Final Product/Process Change Notification

Document #:FPCN23658ZO

Title of Change:	Wafer fab transfer to onsemi Gresham, Oregon USA from onsemi Fab2, Oudenaarde, Belgium related to Fab2 sale
Proposed Changed Material First Ship Date:	28 Aug 2022 or earlier if approved by customer
Current Material Last Order Date:	31 Mar 2022 #PD24322Z <i>Orders received after the Current Material Last Order Date expiration are to be considered as orders for new changed material as described in this PCN. Orders for current (unchanged) material after this date will be per mutual agreement and current material inventory availability.</i>
Current Material Last Delivery Date:	27 Aug 2022 <i>The Current Material Last Delivery Date may be subject to change based on build and depletion of the current (unchanged) material inventory</i>
Product Category:	Active components – Integrated circuits
Contact information:	Contact your local onsemi Sales Office or Jelle.Genne@onsemi.com
PCN Samples Contact:	Contact your local onsemi Sales Office to place sample order. Sample requests are to be submitted no later than 45 days after publication of this change notification. Samples delivery timing will be subject to re

Marking Changes

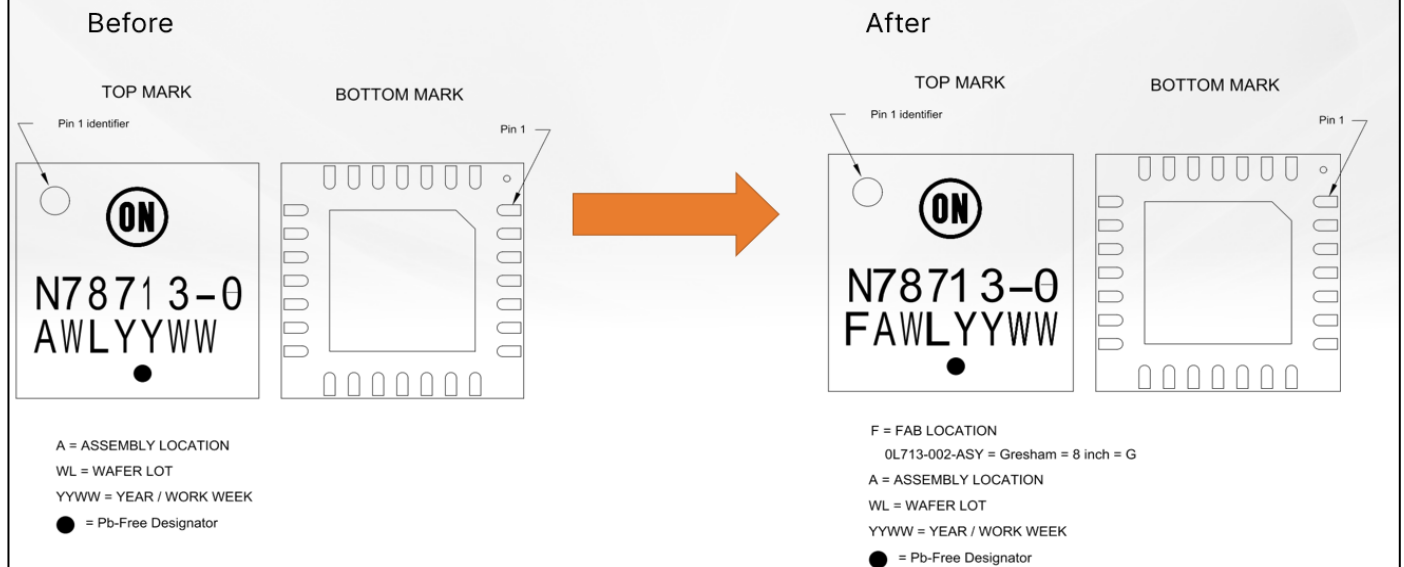
Page 1:
New package and updated marking diagram:

QFN24
CASE 485CS

MARKING DIAGRAM

N78713 = Specific Device Code
A = Assembly Location
WL = Wafer Lot
YY = Year
WW = Work Week
• = Pb-Free Package
(Note: Microdot may be in either location)

QFNW24
CASE 484AF

MARKING DIAGRAM

N78713 = Specific Device Code
F = Fab Indicator
A = Assembly Location
WL = Wafer Lot
YY = Year
WW = Work Week
• = Pb-Free Package
(Note: Microdot may be in either location)
